RE: Washington Square Drainage Requirements

The Engineering Division has completed the drainage study in connection with the above-mentioned plat. Listed below are the comments and requirements for the necessary drainage improvements:

NO. 2351 A-T  
drainage easement

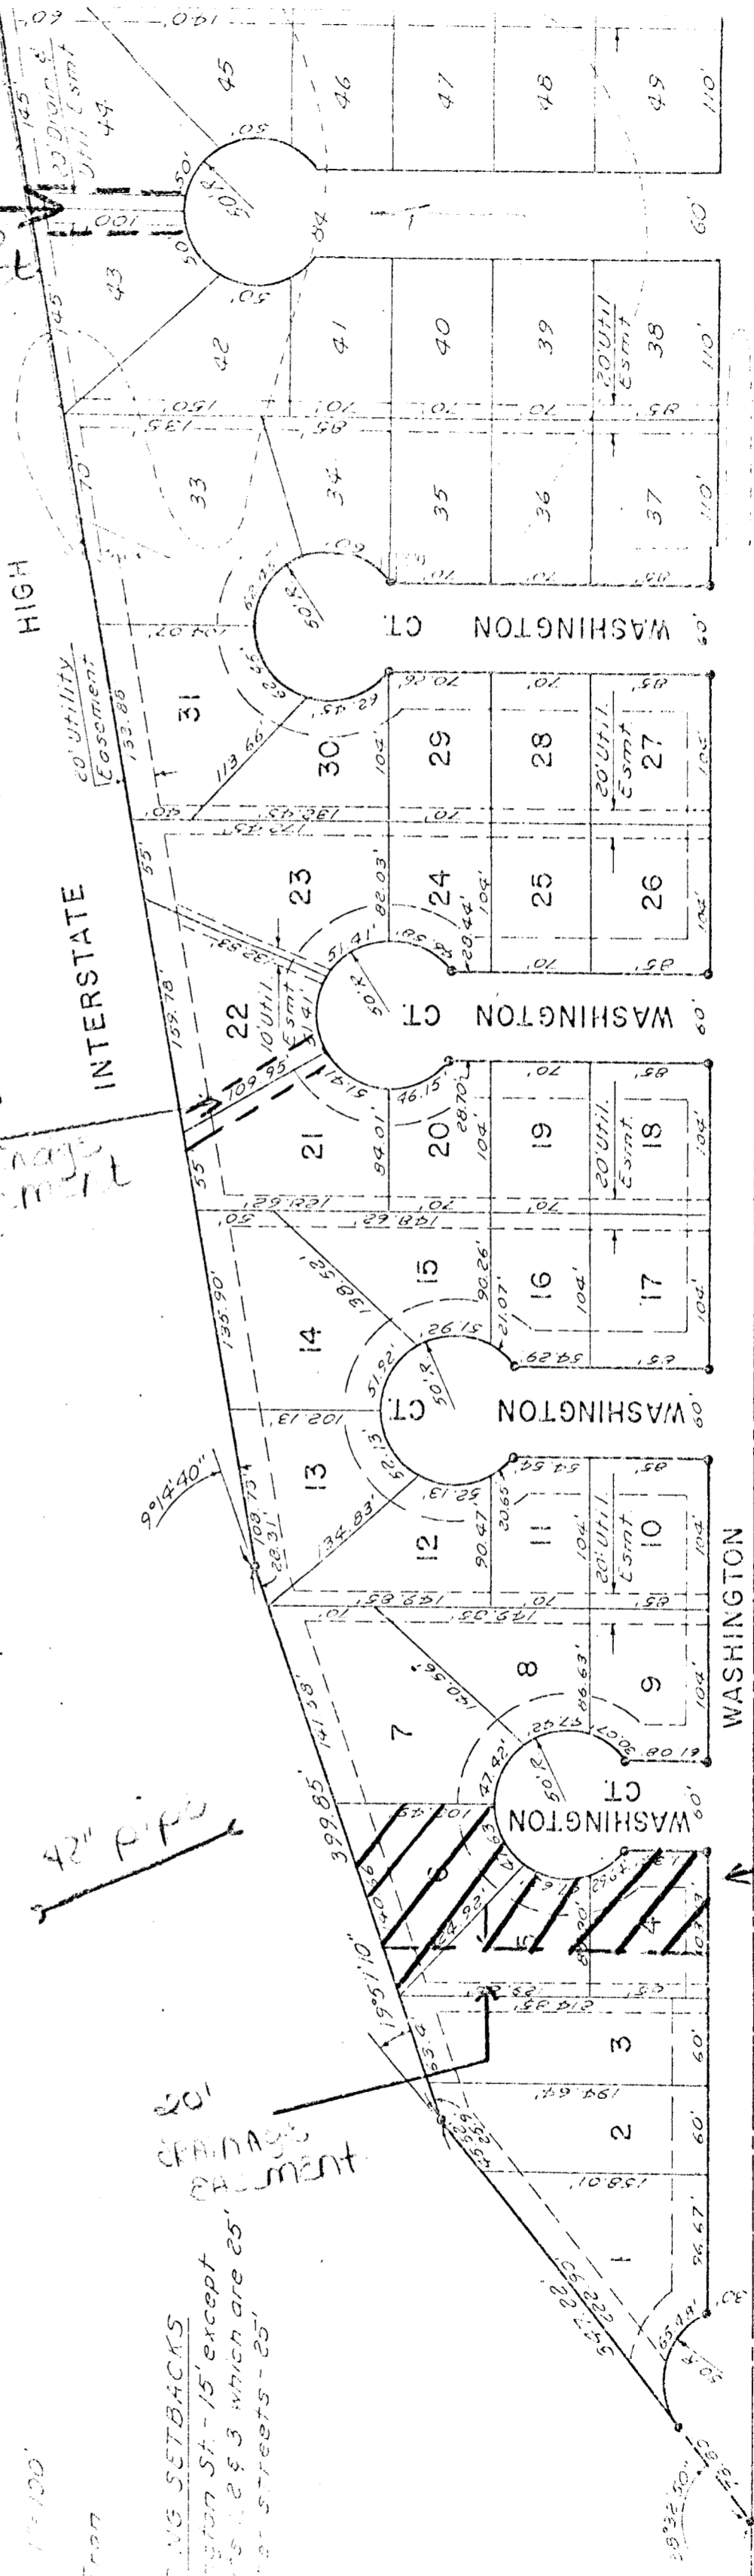
1. A 48-inch diameter pipe must be installed under the Interstate @ elevation 74.35<sup>±</sup> (upstream flowline). Provisions must be made for an outfall system between this pipe and the Big Slough.

2. A storm water sewer is proposed to be located in 46th Street South. A 20' storm sewer easement will be required on Lots 4, 5, and 6 adjacent to the utility easement. A temporary easement will be necessary on Lots 4, 5, and 6. This will prohibit building construction on these lots until after the storm sewer pipe is installed across these lots.

3. Two of the cul-de-sacs must drain to the Interstate right-of-way via pipes in drainage easements. The other cul-de-sacs can be graded to drain into Washington Avenue.
